# ADDENDUM NO. 4

## BUILDING "R" TOILET ROOMS RENOVATION

NTD #2007-SH29-01

Pasadena City College  
1570 E. Colorado Blvd.  
Pasadena, California 91106

**E0.1**

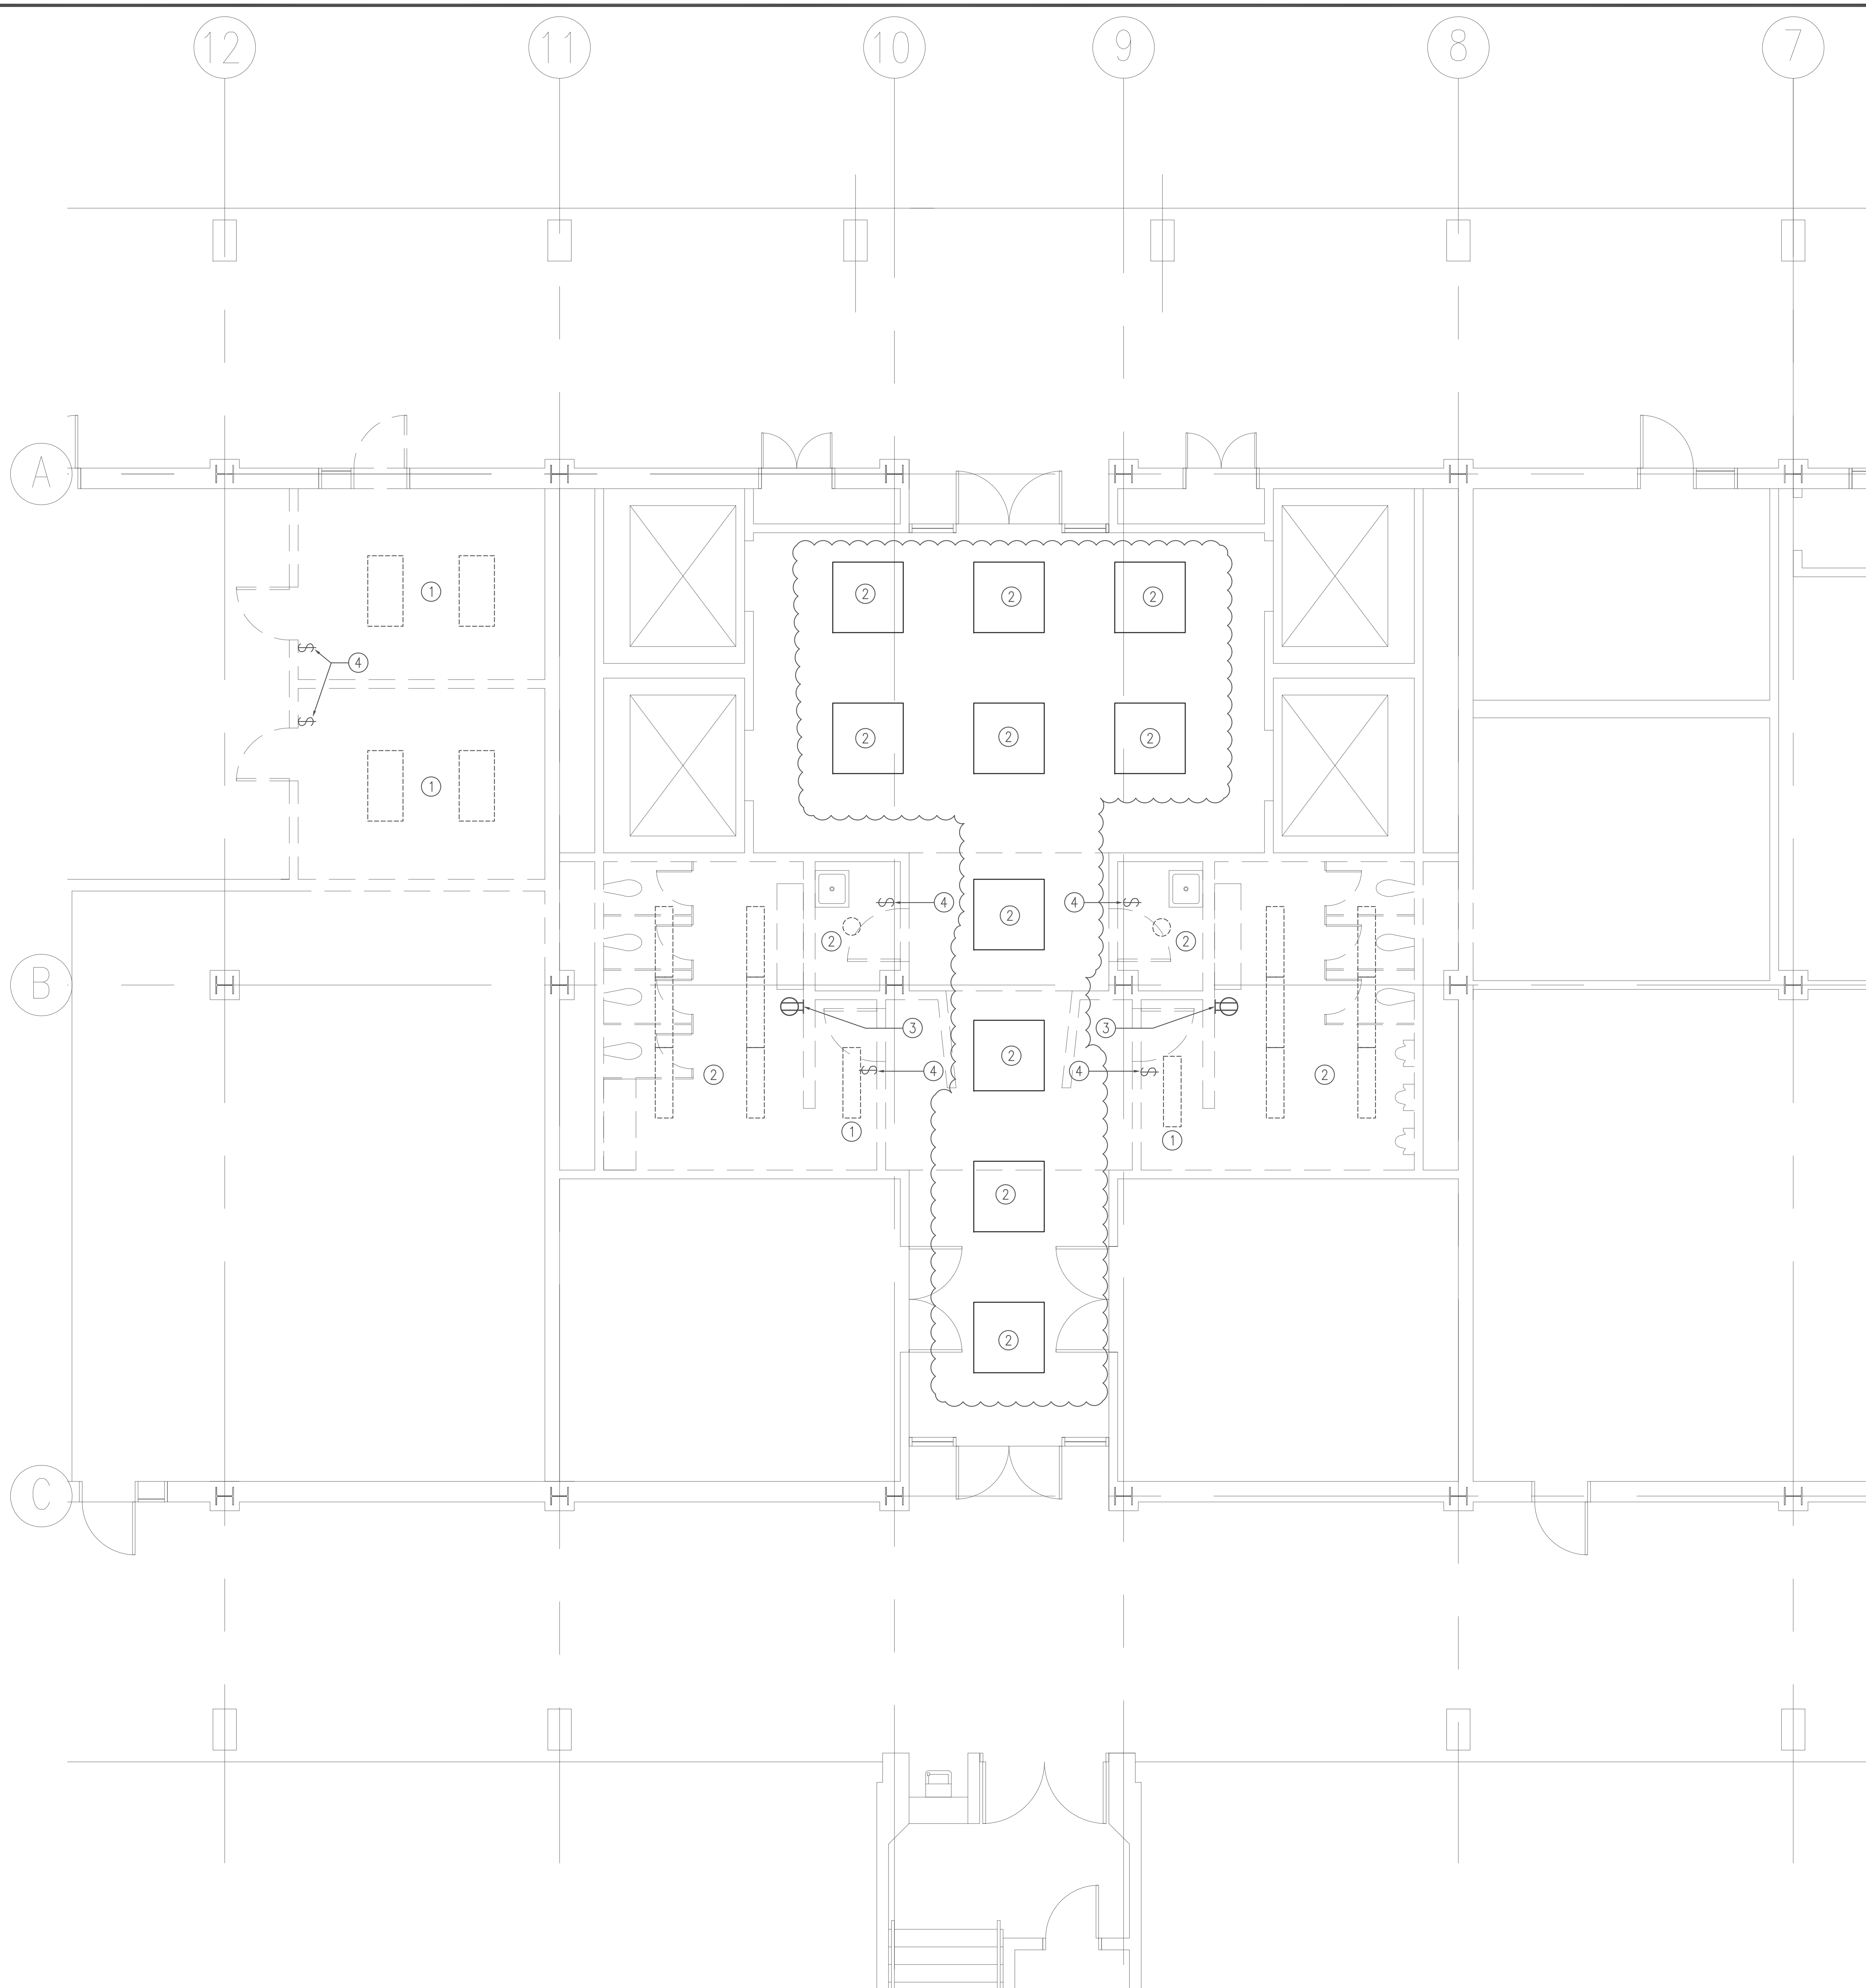
**3.1.1.1.** Revise to remove all existing light fixtures in both existing Elevator Lobby and Foyer per the attached Drawing E0.1 (Addendum #4), clouded revision. .

**3.2.1.** Drawing E0.1 – Modify as follows:

**3.2.1.1.** Revise to remove existing 4x4 light fixtures per the attached Drawing E0.1 (Addendum #4), clouded revisions. Reference Drawing AD2-A05 for Base and Alternate Bids' scopes of work.

**E2.1**

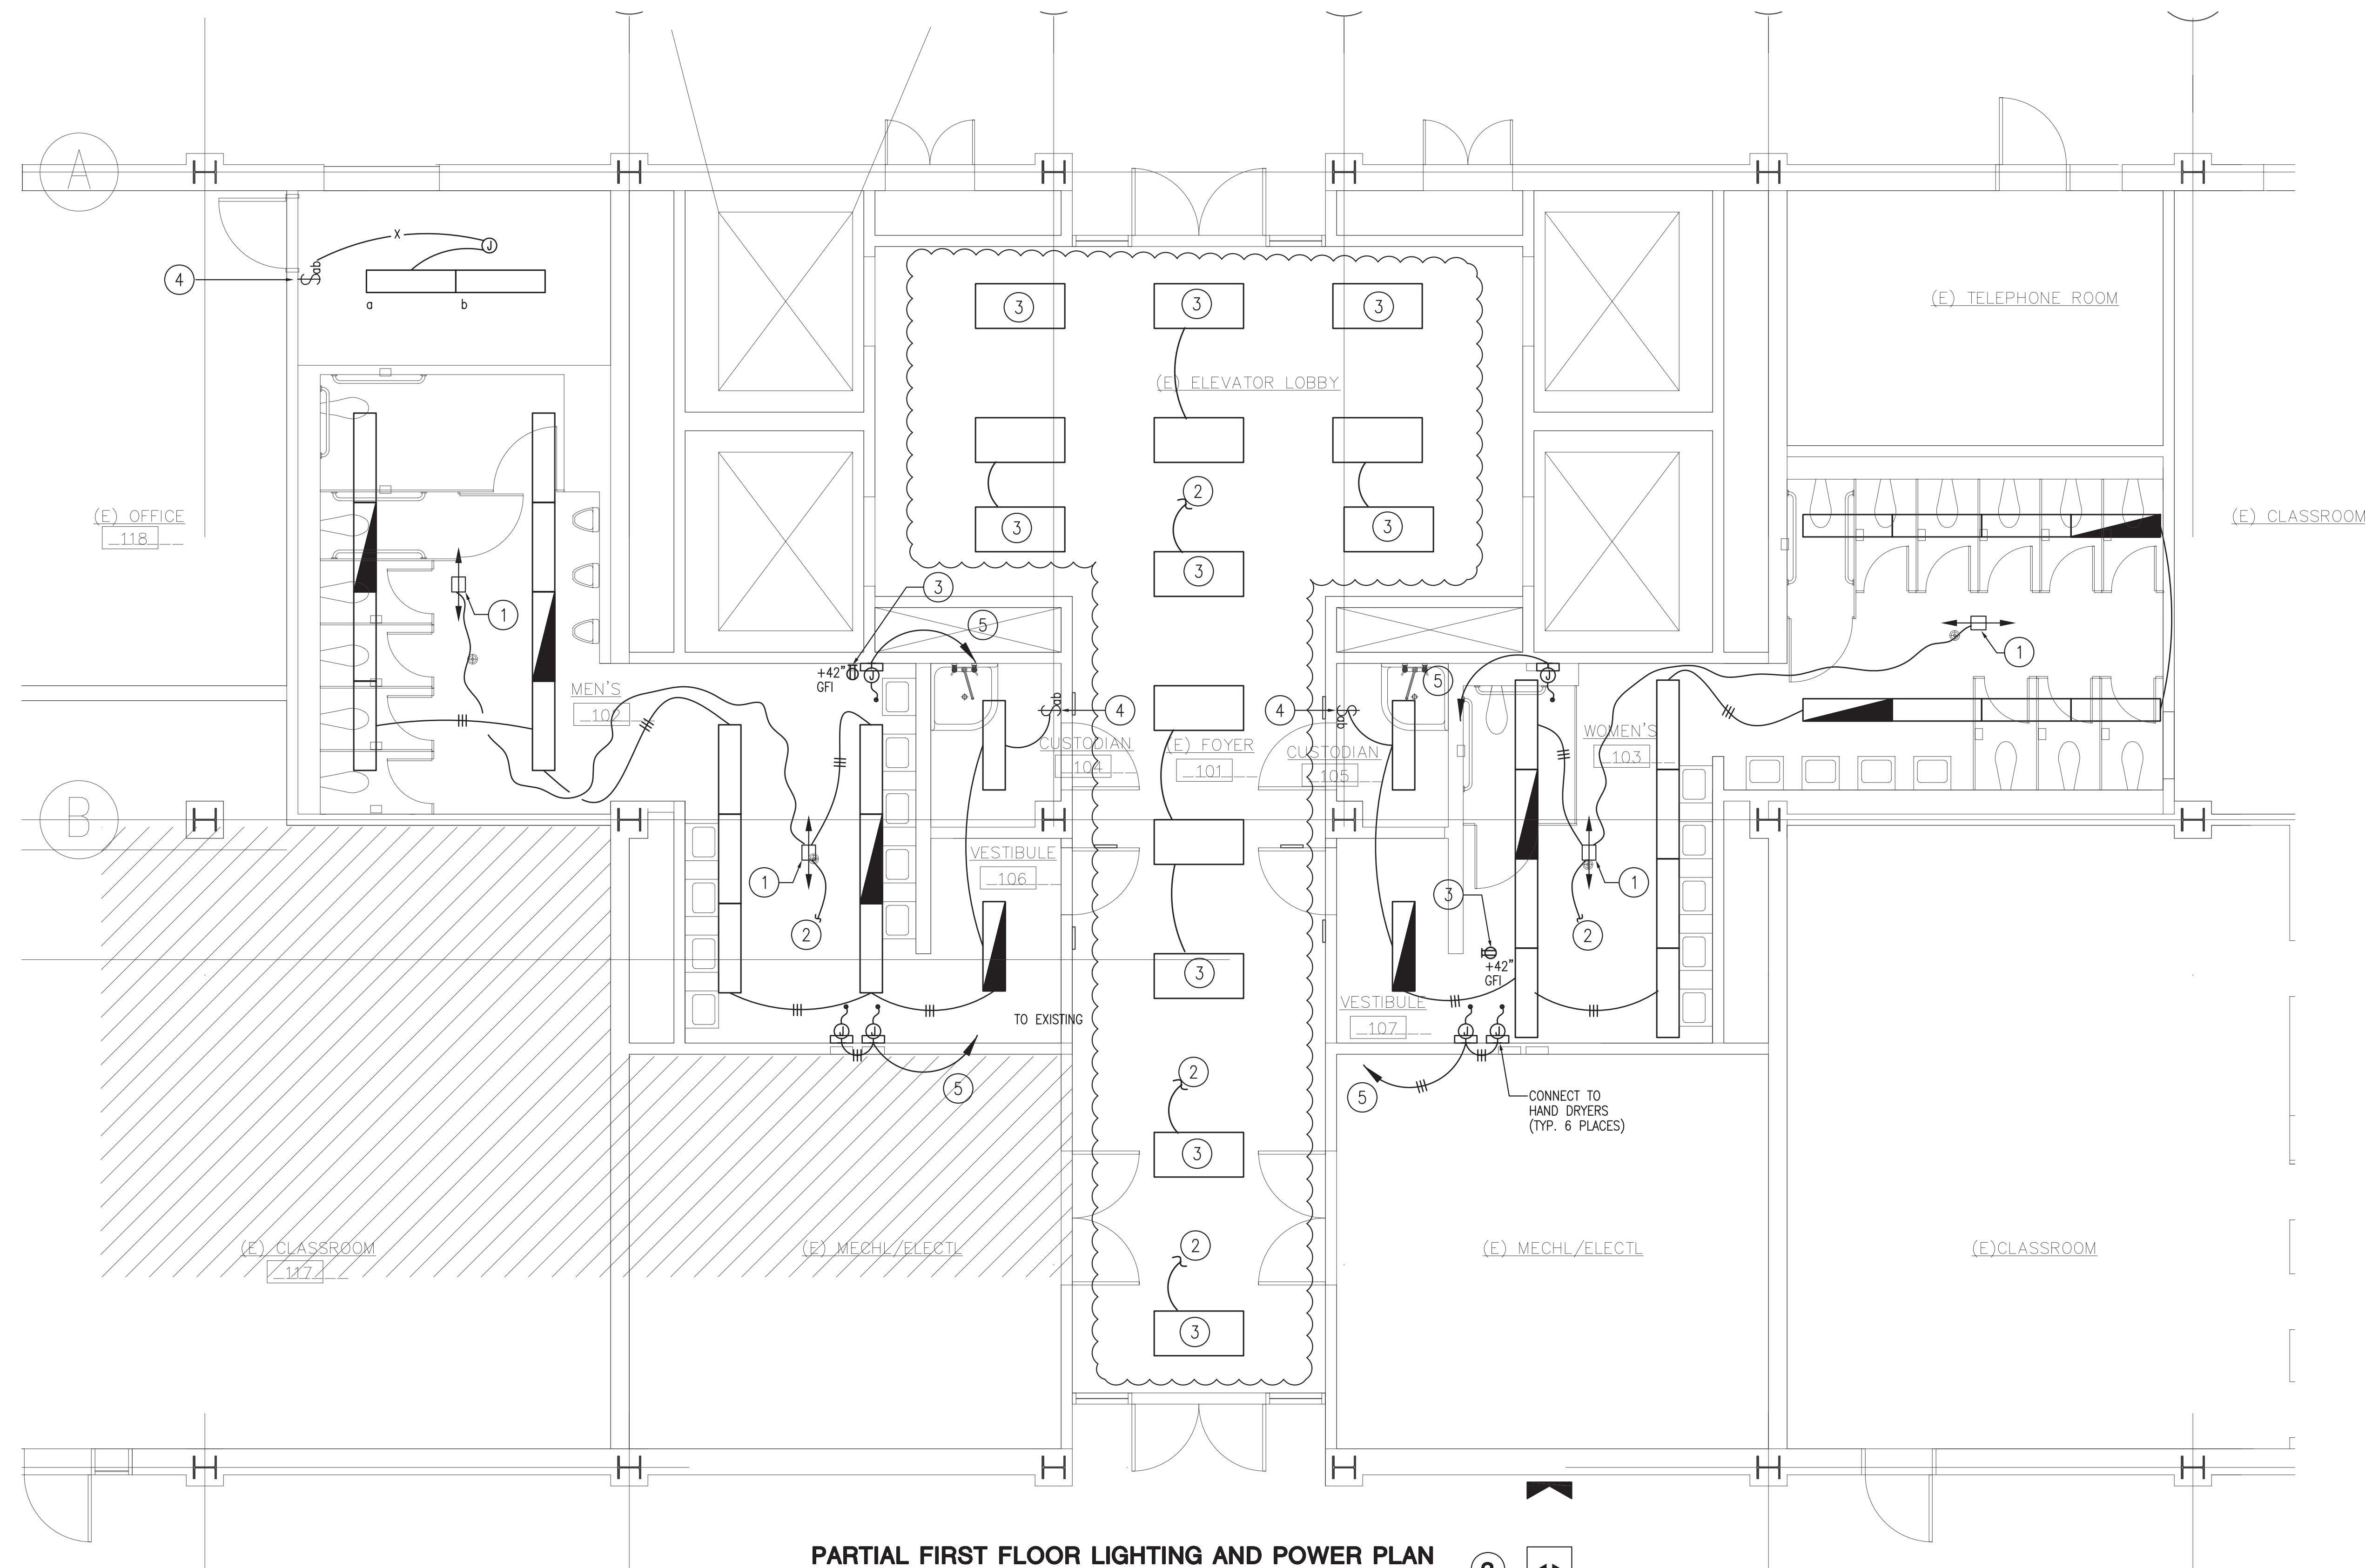
**3.1.2.1.** Revise to furnish and install all 2x4 light fixtures in both existing Elevator Lobby and Foyer per the attached Drawing E2.1 (Addendum #4), clouded revisions.

**3.2.2.** Drawing E2.1 – Modify as follows:

**3.2.2.1.** Revise to provide and install 2x4 light fixtures per the attached Drawing E2.1 (Addendum #4), clouded revisions. Reference Drawing AD2-A06 for Base and Alternate Bids' scopes of work.
